LiDAR Quality Assessment Report

KS_SthCentralAOI3_2015

Applicable Specification:
NGP LiDAR Base Specification V 1.2

Checkpoint Distribution Image

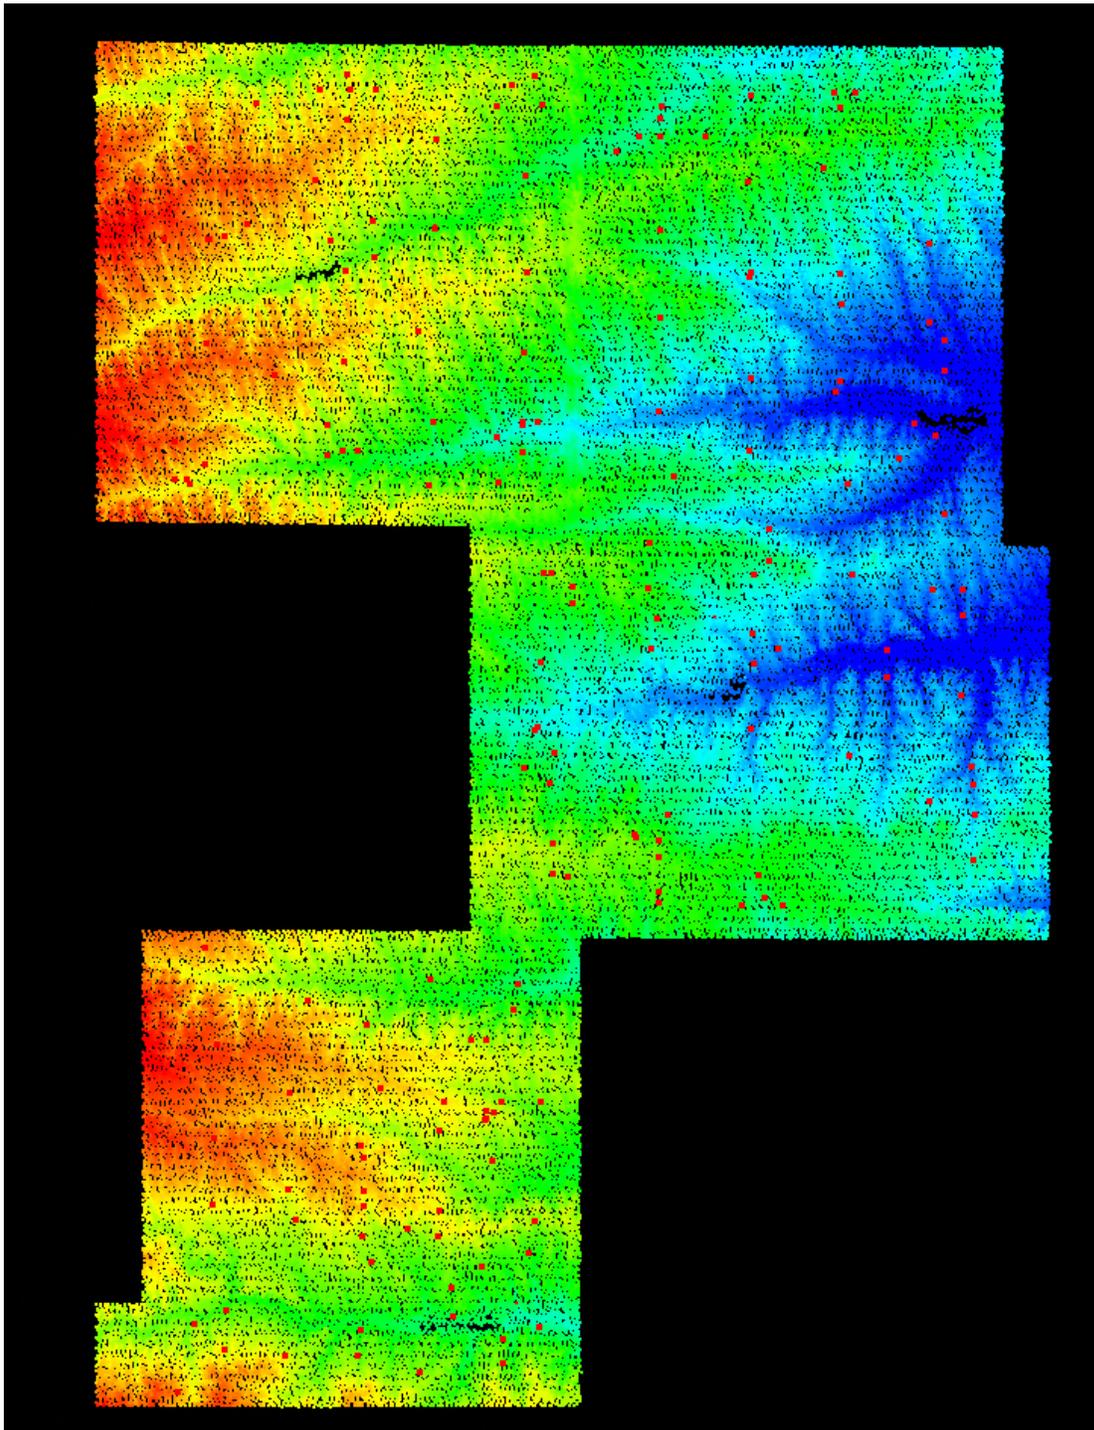
Swath Vertical Accuracy fails when full 116 points are ran, below is explanation from Atlantic Group, LLC 4/8/216

We were not able to use 2 NVA checkpoint (OT52 and OT53) in our calculations due to the reported high slope.

If you could double check the values, we would appreciate it. We believe there must have been a mistake due to the data passing our vertical accuracy assessment as well as Dewberry's vertical accuracy assessment.

Ran vertical accuracy with-holding the 2 points mentioned above, and accuracy passes.
